ADDENDUM #4

REQUEST FOR QUOTATIONS (RFQ) NO.:	1220-040-2017-114
TITLE:	FLEETWOOD RECREATION CENTRE ROOF REPLACEMENT
ADDENDUM ISSUE DATE:	November 10, 2017
REVISED CLOSING DATE:	prefer to receive Quotations on or before: November 17, 2017

TITLE: ROOF PLAN

R1(REV.1)

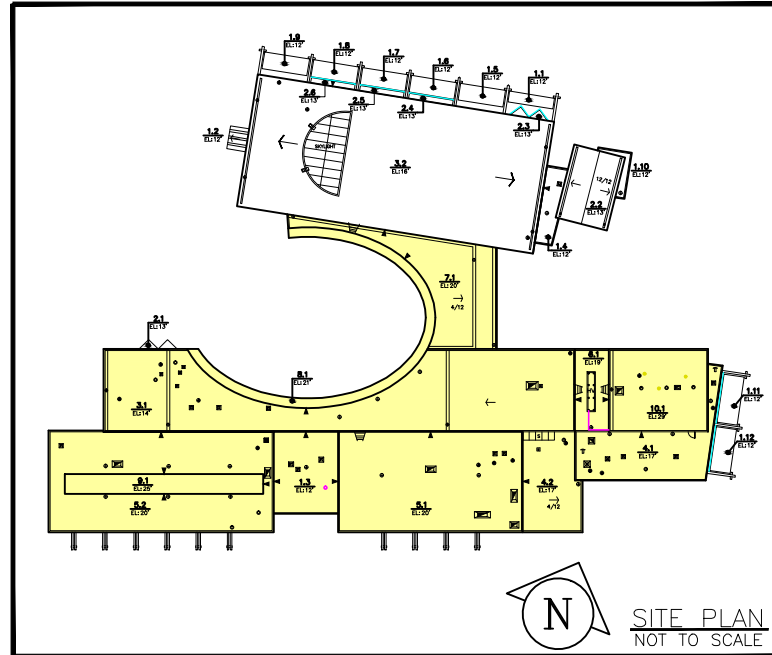
Q3: Can we please get a drawing with the proposed walkways? The spec is very vague about where we are expected to install these and making incorrect assumptions could prove very costly to us.

Please find attached Revised Roof Plan R-1 with two (2) additional locations marked to receive pavers.

A3: Install 24" x 24" x 2 " HydraPressed Slabs by Abbotsford Products as per Detail VVMN033 at locations identified on Roof Plan R-1 of the RFQ. Roof Plan contains 2 pavers at landings for doors, walkways, etc. as defined in Item 3.19.1 of Section 07 52 00, in lieu of specified membrane walkway material.
